LCA 188
Attachment B
Page 1 of 1

FIGURE 3.4-2 REACTOR COOLANT SYSTEM PRESSURE — TEMPERATURE LIMITS VERSUS 60°F/HOUR HEATUP RATE — CRITICALITY LIMIT AND HYDROSTATIC TEST LIMIT

I hereby certify that copies of License Change Application 188 to the Operating License for Trojan Nuclear Plant, dated December 20, 1989, have been served on the following by hand delivery or by deposit in the United States mail, first class, this 20th day of December 1989:

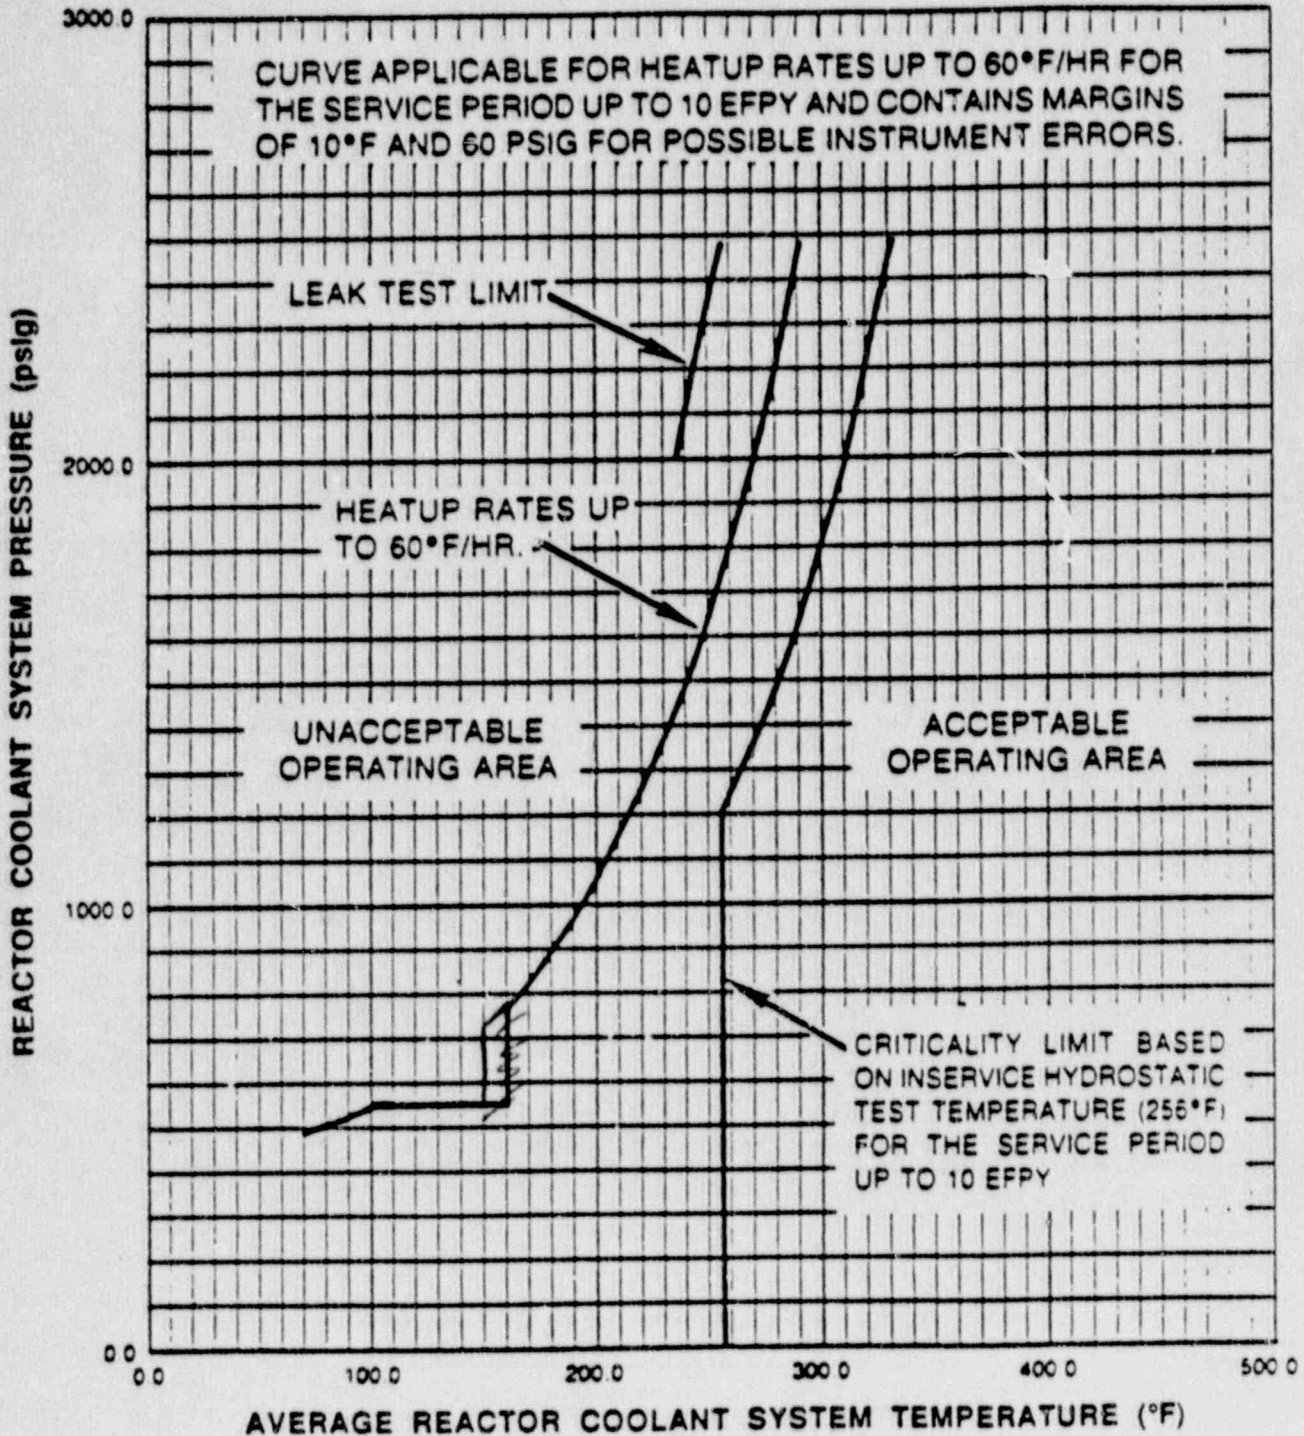
CONTROLLING MATERIAL : R.V. LOWER SHELL
 COPPER CONTENT : 0.16 WT%
 PHOSPHORUS CONTENT : 0.012 WT%
 INITIAL RT_{NDT} : 10°F
 RT_{NDT} AFTER 10 EPFY : ¼T, 111°F
 : ¾T, 55°F
